ACC
PRODUCT ENGINEERING

File name:
X23-575_867_603____GEO_EN__005_____RVTO_MARCO_LUNETA__B-GUSS_KW29___170714_SE376_ACC_141020_003.CATPart

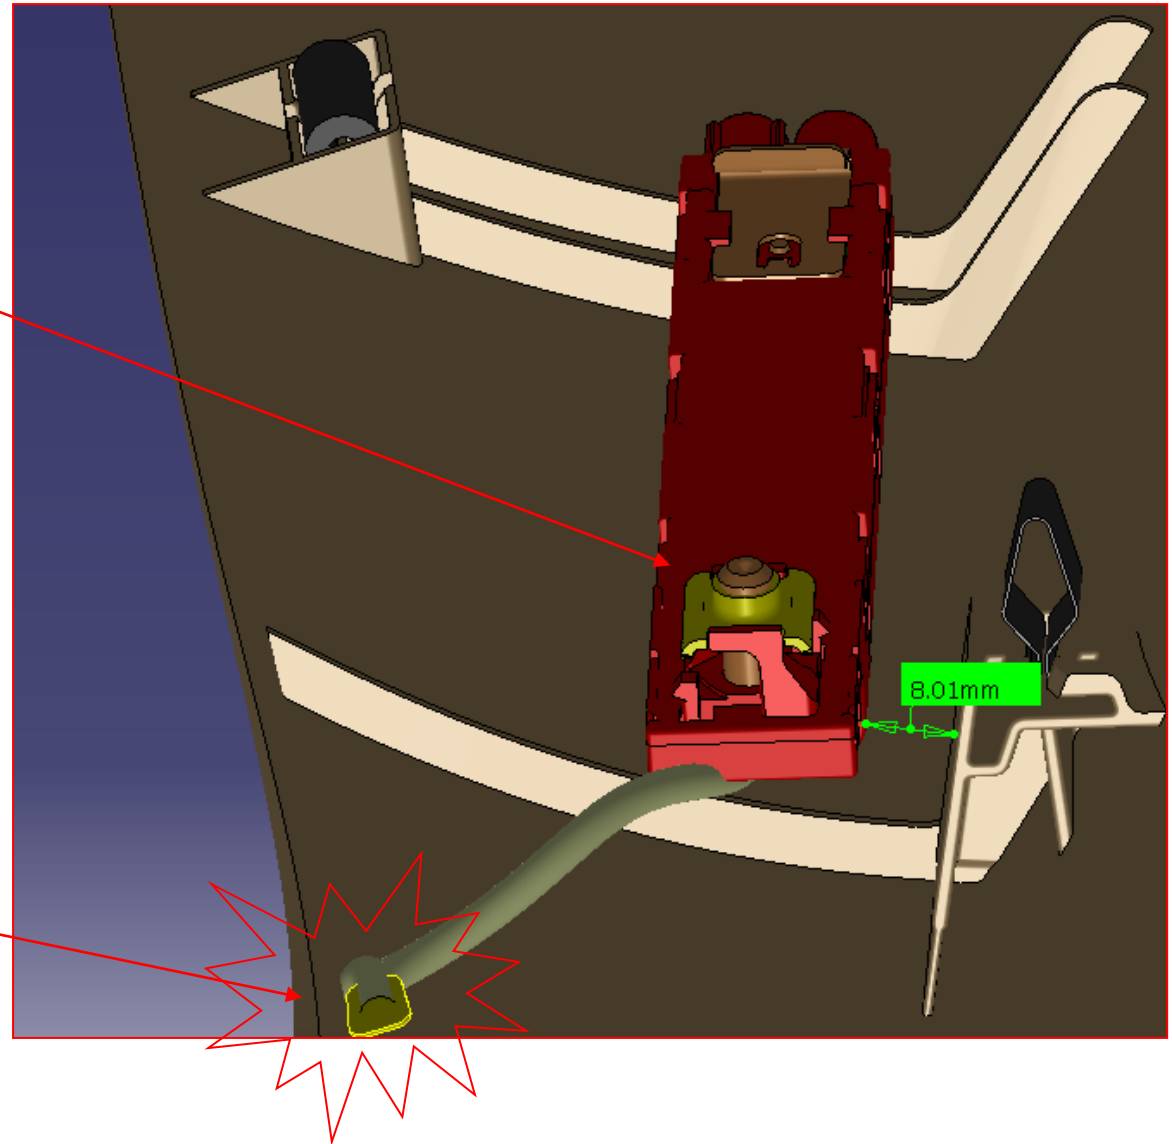
Minimum gap in X direction (real size) 8mm

Cable in clash

Notice: the cable was find in no show.

o.k.

I will inform Seat in case is important

Minimum gap in Z direction (real size)

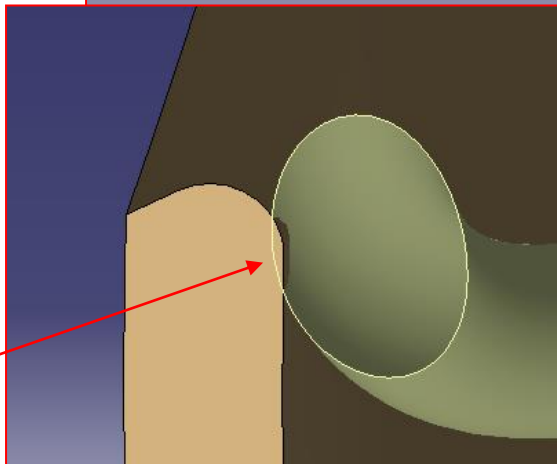
5 mm (rib high 5mm)

Cable in clash

Notice: the cable was find in no show.

o.k.

I will inform Seat in case
is important

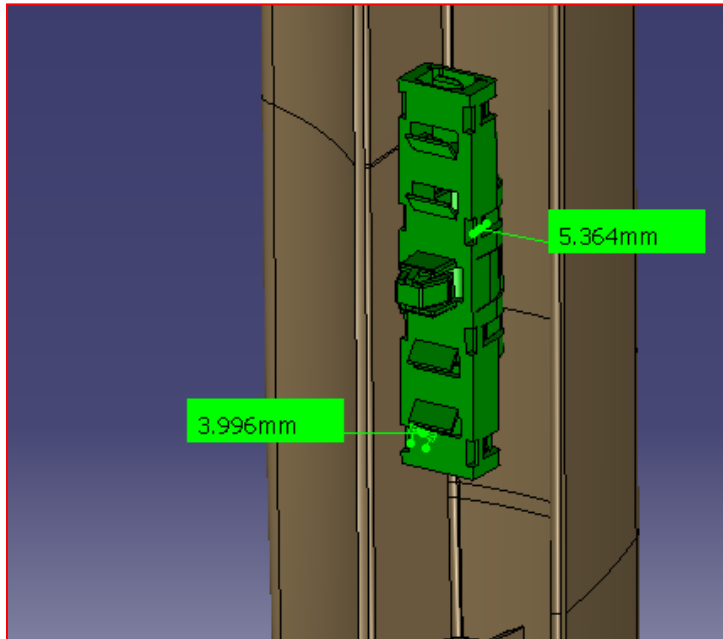
Clash max 0.21mm between upper

part EOP and cable
(EOP = end of part)

*SHOULD WE MAKE A CUTOUT
IN ORDER TO AVOID THIS

INTERFERENCE?*

CLERANCE ?

No

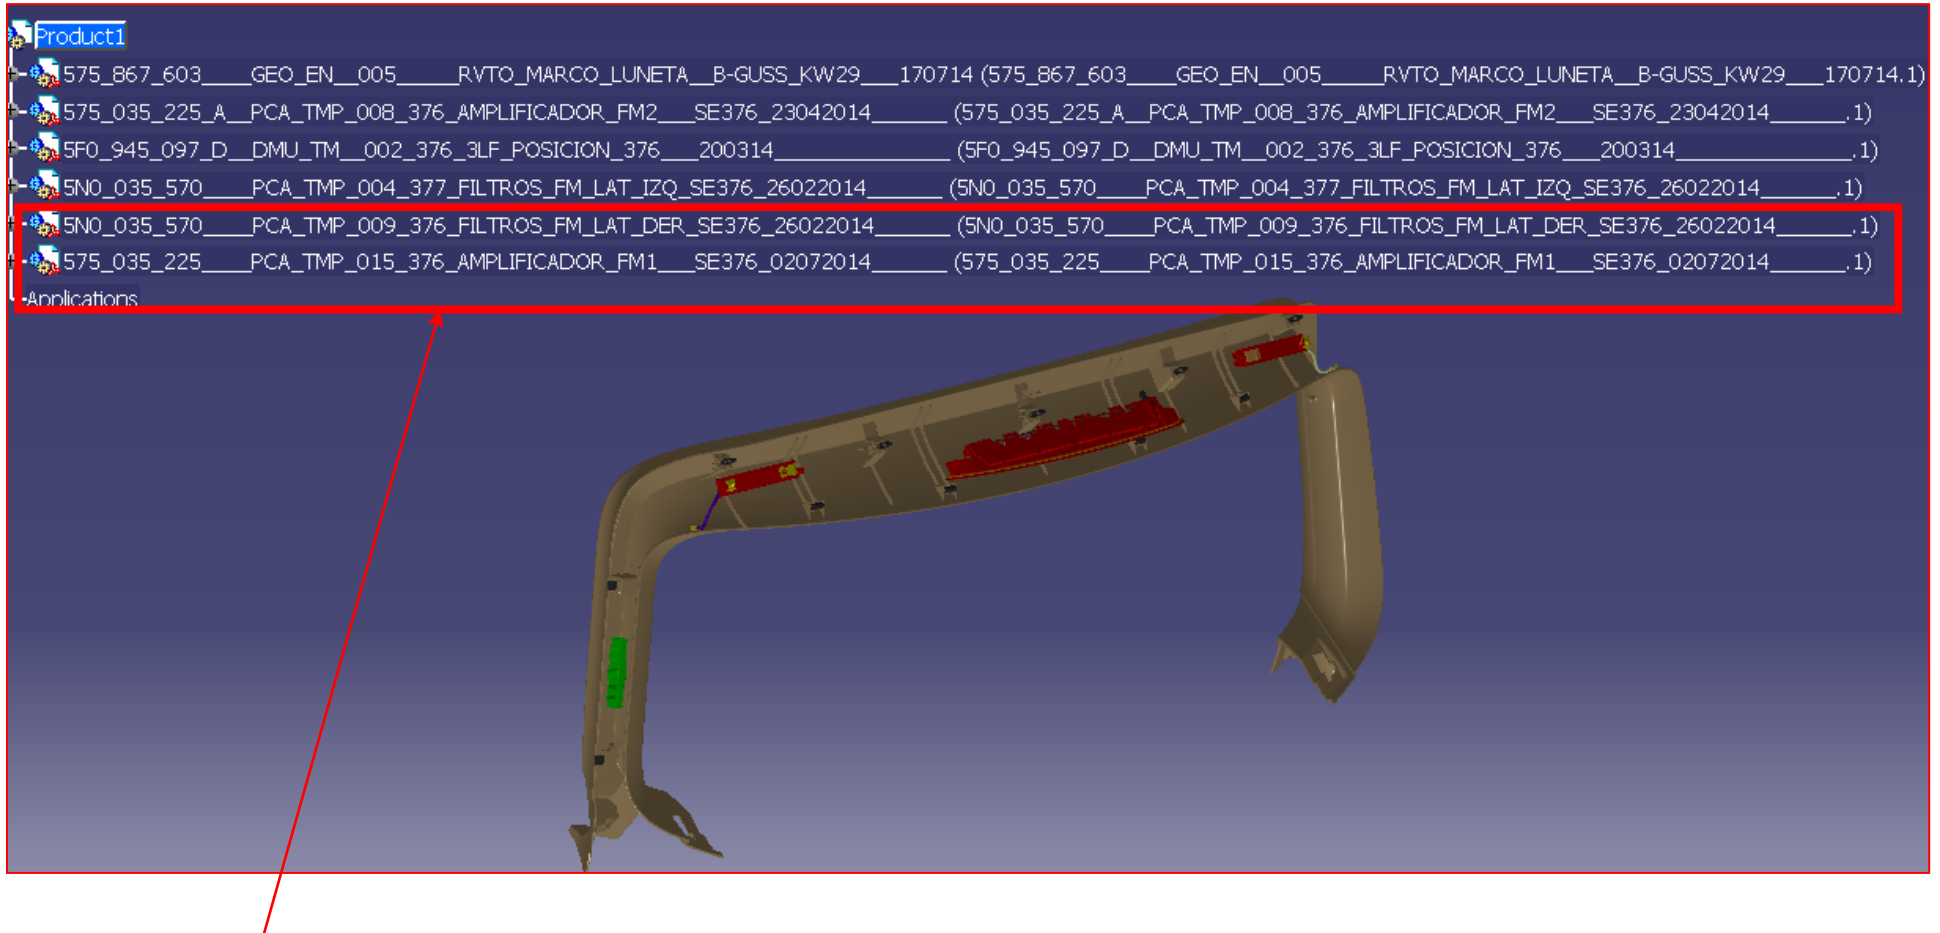
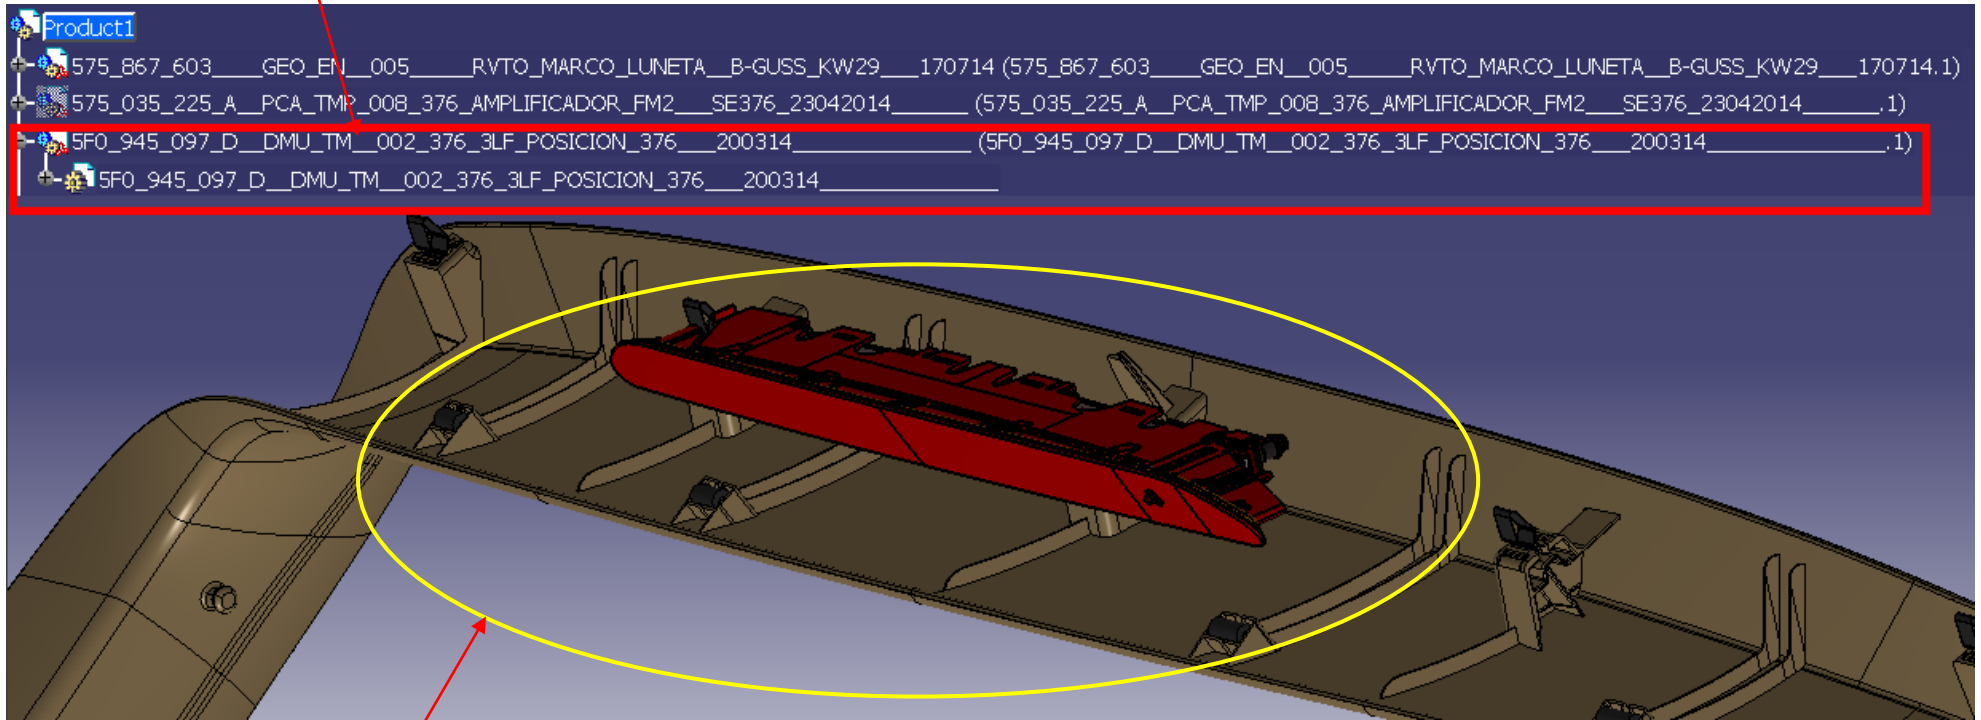
Minimum gap in X direction 4.0 mm against gass canal

Minimum gap in Y direction 5.3 mm against B face

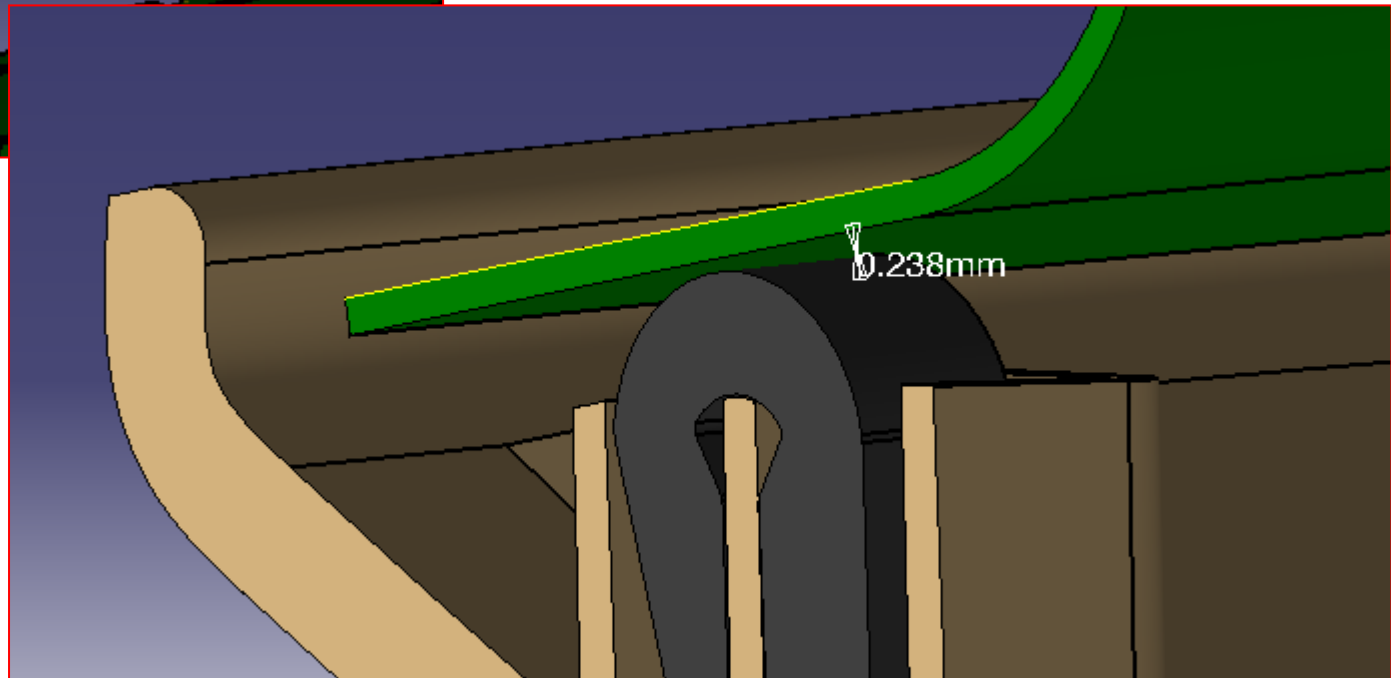
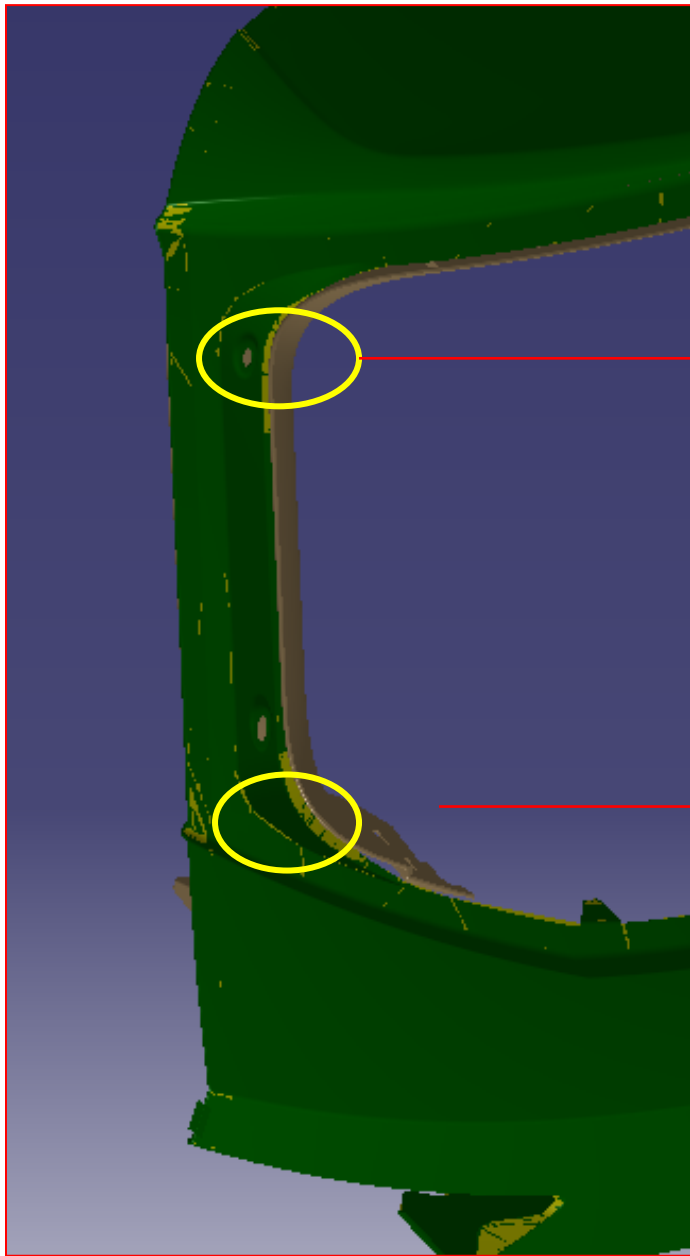
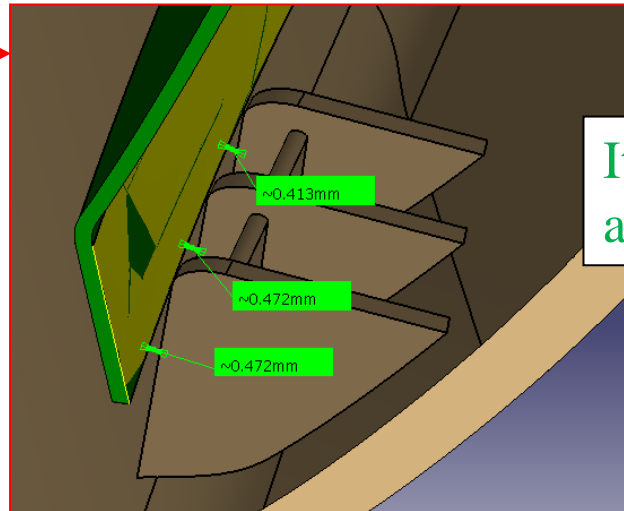
We should have clash as in this picture

Minimum distance 0.24mm no clash

Clerance0.2mm with GUMMIE

Clerance 0.5mm

PLEASE SPECIFY IF 0.413 IT COULD BE CONSIDERED CORRECT, OR, WE SHOULD PASS TO 0.5mm.

Clerance 0.4-0.5mm

It is correct. This will be an adjustment area

SECTION VIEW ON RIBS AREA

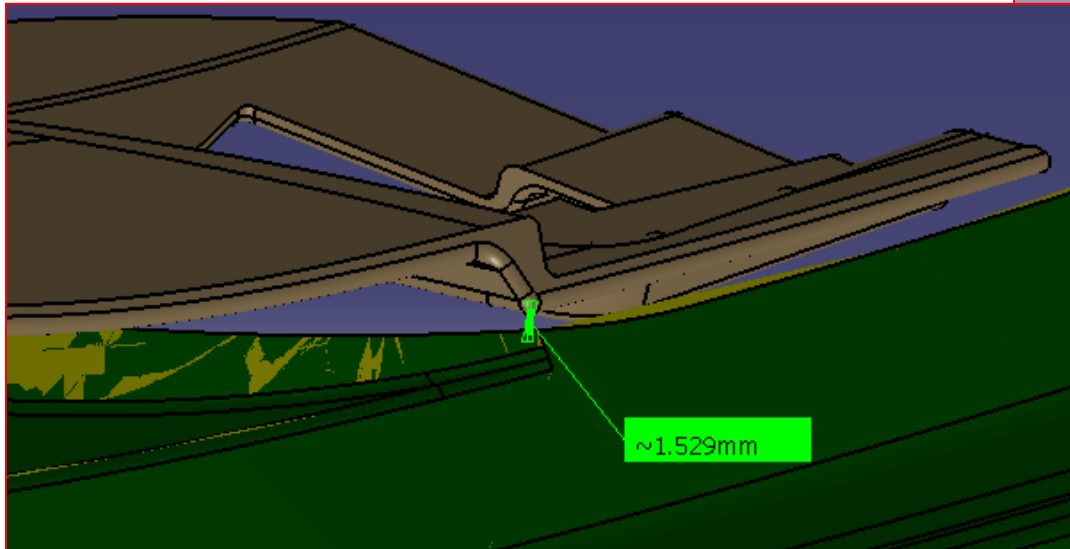
PLEASE SPECIFY IF THE 1.5mm GAP IS GOOD ENOUGH.

GAP 1.5 mm

o.k.

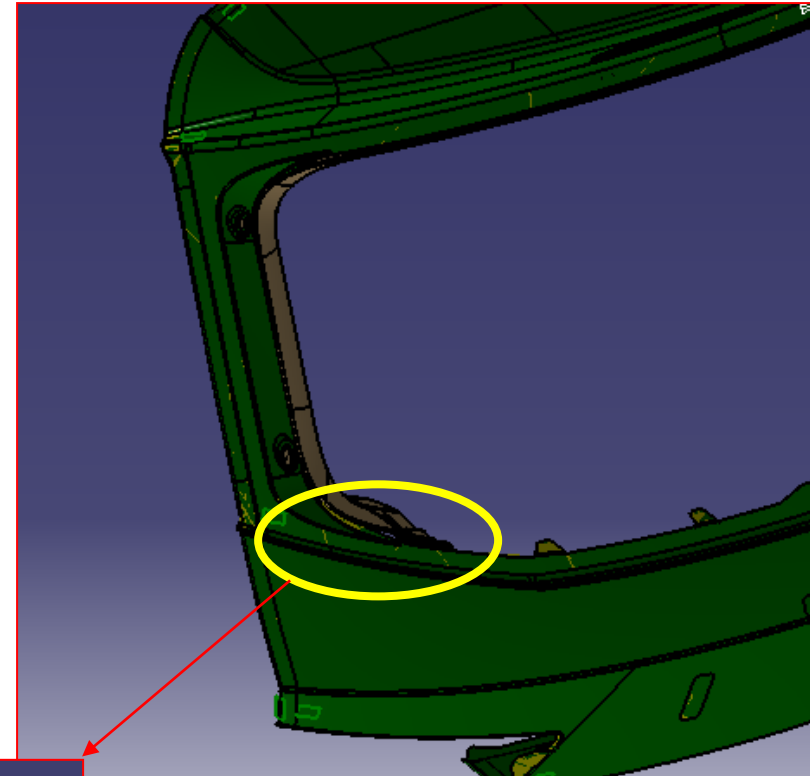
PLEASE SPECIFY IF THE 3 mm GAP IS GOOD ENOUGH.

3mm gap between B face and EOP of sheet metal part on the upper ligne.

o.k.
